Project #21-007 8th & Main Addition 1224 North Main Street, TIN #05-014-0071

Submitted By: Tanya Rice, Planner II February 25, 2021

RECOMMENDATION

Staff recommends that the Planning Commission **conditionally approve** a Design Review Permit for Project #21-007 8th & Main Addition, in the Commercial (COM) zone located at 1224 North Main, TIN #05-014-0071.

Figure 2 shows the proposed facades of the addition.

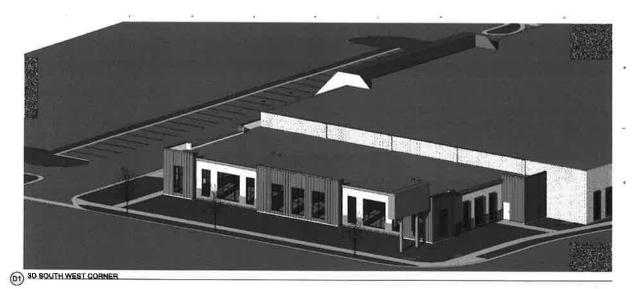
The LDC §17.12. promotes high quality and aesthetically designed commercial development. The building addition faces Main Street and is clearly visible from both Main and 1250 North. The entrance to the addition is from inside the existing building. It has one roll up service door and one employee access door on the north side and one employee access door on the south side. The proposed building provides variety by changes in metal panel material color; recessed openings; breaks for windows and doors; contrasting compatible building material; and changes in roof height. As proposed, all elevations comply with the requirements of the LDC.

Figure 3 shows the trellising on south facing facades of the new and existing buildings.

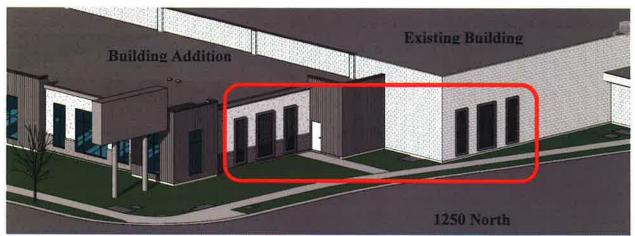
On the south facing façade along 1250 North, the proposal includes a window, door and a non-transparent fenestration alternative of three (3) trellises to meet the minimum transparency requirement. In addition, the trellising is replicated on the existing building to provide architectural continuity and improve the overall street appeal along 1250 North (see Figure 3).

Since the addition will be used to warehouse furniture for the existing store and transparency is not essential for business, staff recommends approval of the trellising as a fenestration alternative. As proposed, with trellising on the south facade of the addition, the project complies with the requirements in the LDC.

- 1. All standard conditions of approval will be recorded with the Design Review and are available in the Community Development Department.
- 2. The Planning Commission permits the proposed window, door and non-transparent fenestration alternative of three (3) trellises to meet the minimum transparency requirement on the south facade.
